Traditions II - Block 349 Medium Density

Servicing and Stormwater Management Report

**Reference: 1883 Stittsville Main
Response to First Formal Review Comments (D07-12-24-0142)
Our File No.: 124097**

GRADING PLAN AND EROSION AND SEDIMENT CONTROL PLAN

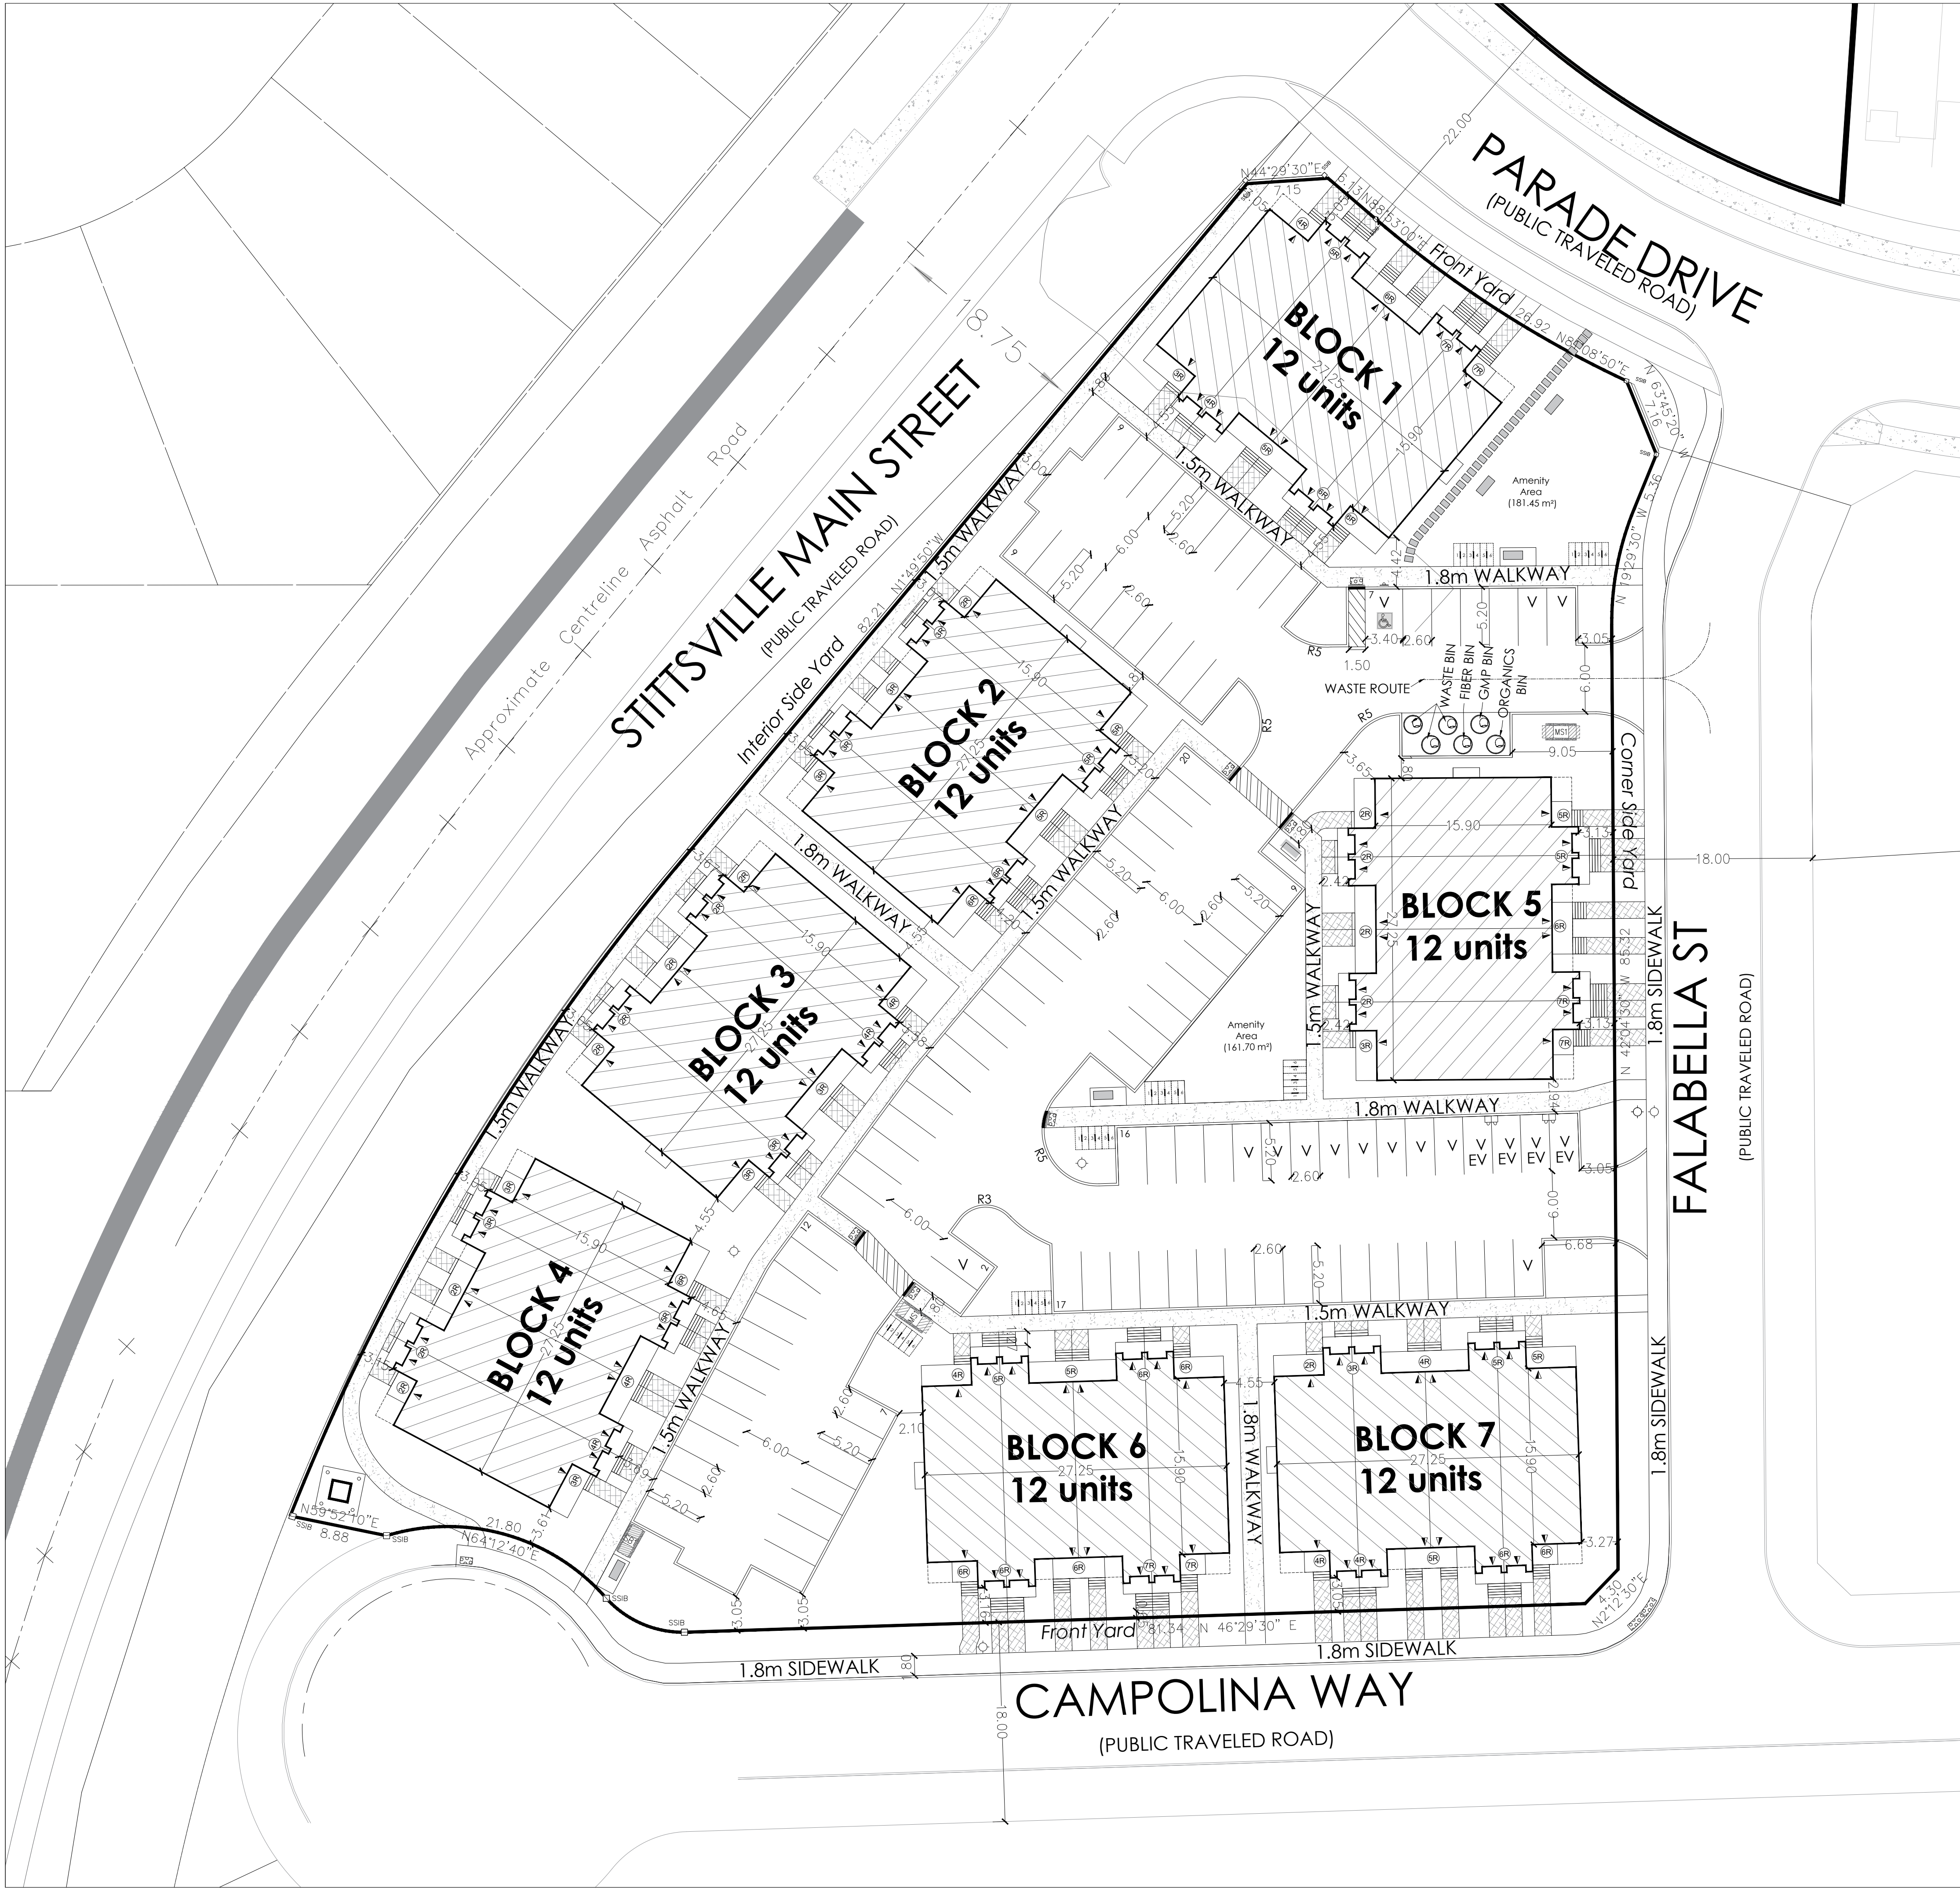
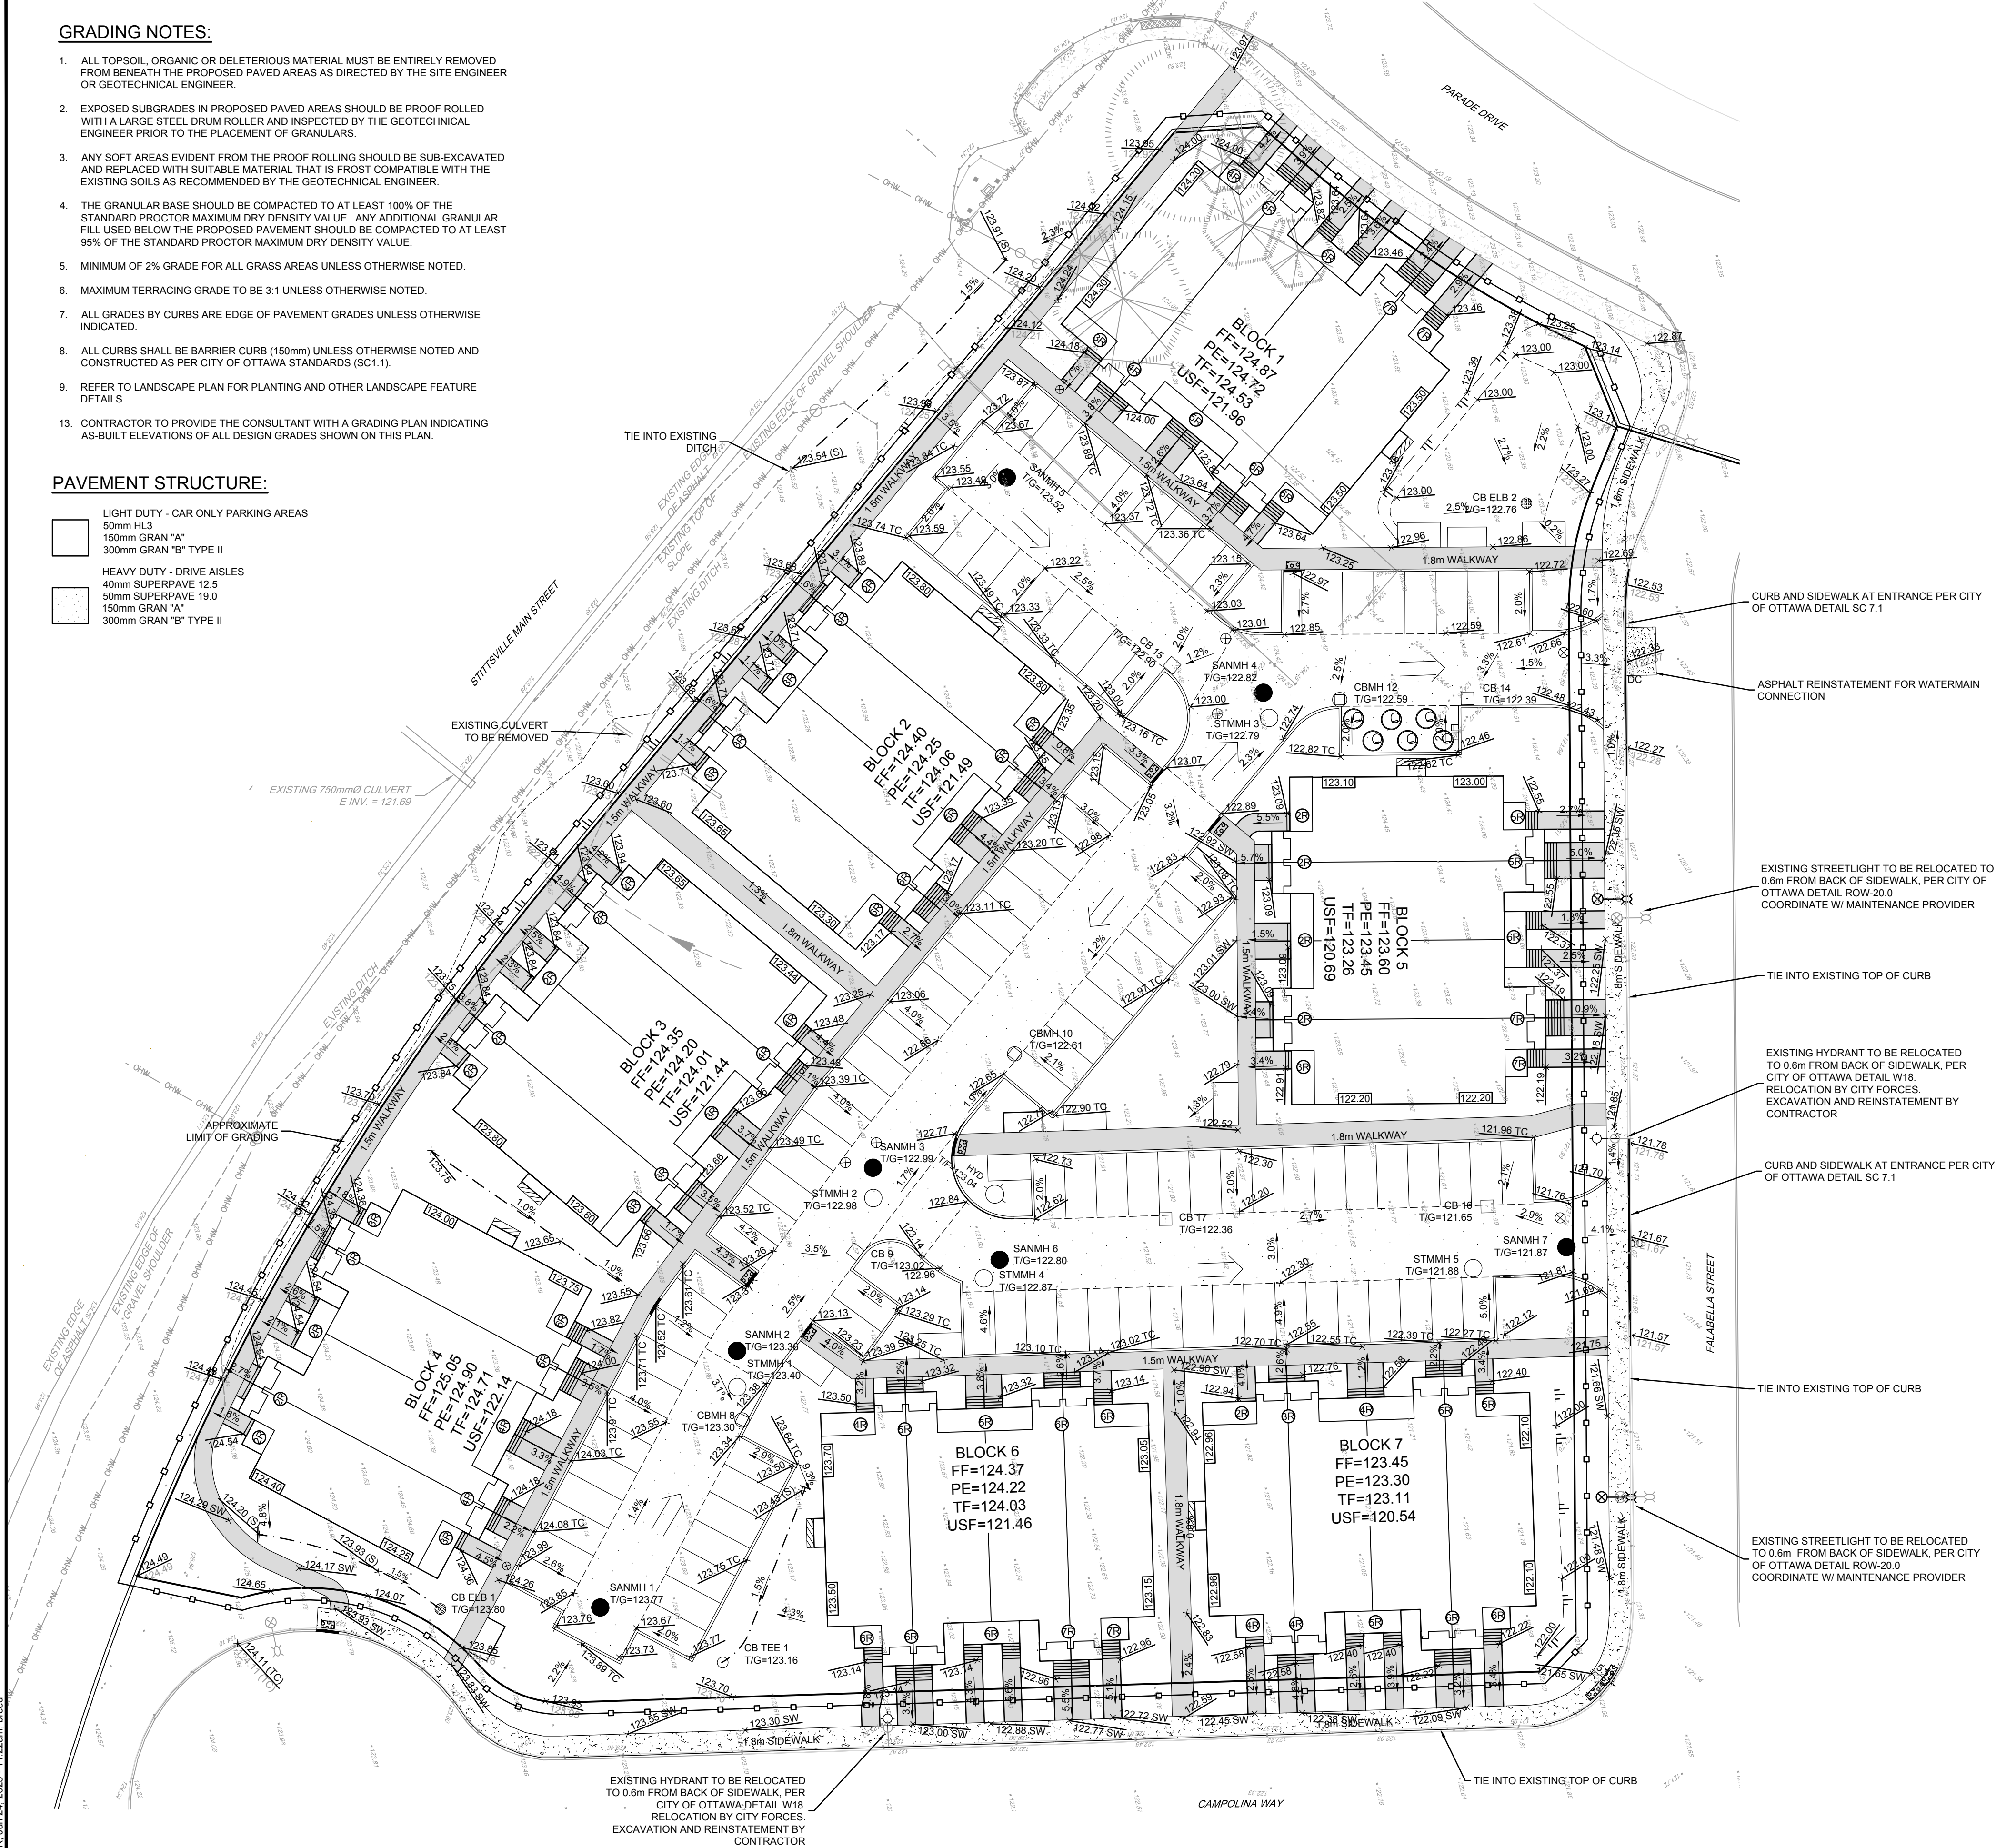
24. If the Grading Plan will serve as the ESC Plan as well, please ensure the title of the drawing notes *Grading Plan and Erosion and Sediment Control Plan*, or similar. Please add ESC notes to the drawing.

25. Please add additional grades/slopes between Block 3 and Block 4.

Response: Plan revised

Response: Plan revised
